Contract Change Order # 1

Project Name: Fairway Park Detention - Regional Detention Phase II Project Number: SW0910B
 Project Location: 61st Street between Lynn Lane and County Line Date of Application: Tuesday, July 26, 2016
 Contractor: Lowry Construction Services, Inc. Submitted By: Lowry Hutton

REQUEST FOR INFORMATION NO. #003

Fairway Parks Detention RFI #3 Response:

Figure 6. Typical riprap-lined channel cross-sections. (Source: Ref. 1)

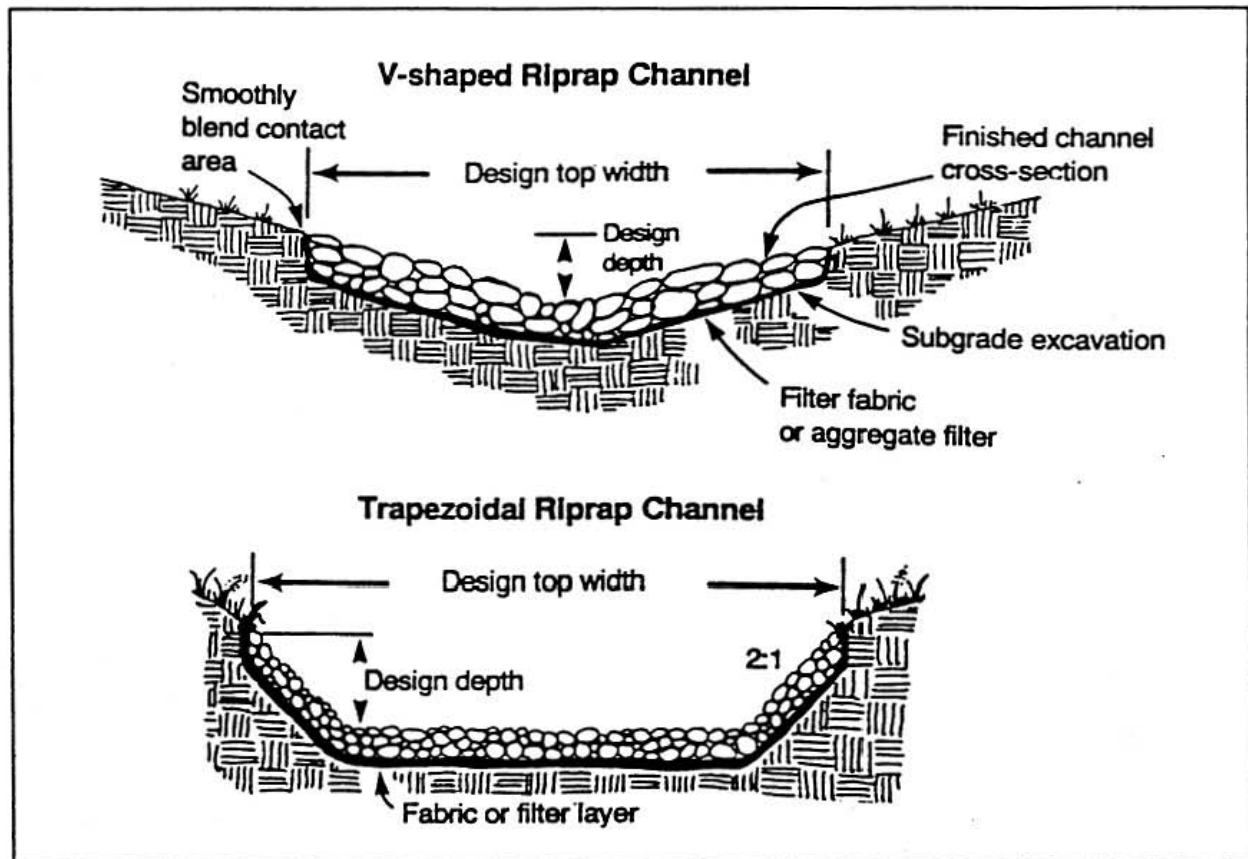
Please provide Specification #601(H) regarding Type IV-Grouted Riprap, indicated on the Pay Quantities table (Sheet 2 of 5).

Please provide dimensional cross-section for the Grouted Riprap details shown on Sheet 5 of 5.

Please clarify quantity of Grouted Riprap. Conflicting quantities appear on Pay Quantities #8 and Pay Item Notes #12, both on Sheet 2 of 5.

Per Pre-construction meeting notes, please provide pricing to replace the 925 SY of grouted rip-rap along the eastern basin with un-grouted rip-rap 18 inches thick per ODOT spec 703.02a, Type 1, with filter blanket - non-woven fabric, ie. US 205NW being an acceptable ODOT fabric. The toe in depth shall be the depth of the rock, see attached figure below. Pricing shall be LS and an itemized cost breakdown shall be included. The existing line item shall be undererran and a reconcile change order shall be processed at conclusion of the project.

The remaining 1,850 SY of grouted rip-rap shall be 12" thickness, without filter blanket, using ODOT spec. 713.02 a3, stone for grouted rip-rap, Type IV. The toe in depth shall be the depth of the rock, see attached figure below.

In clarifying the quantities units issues as requested, the rip-rap shall be paid per SY installed.
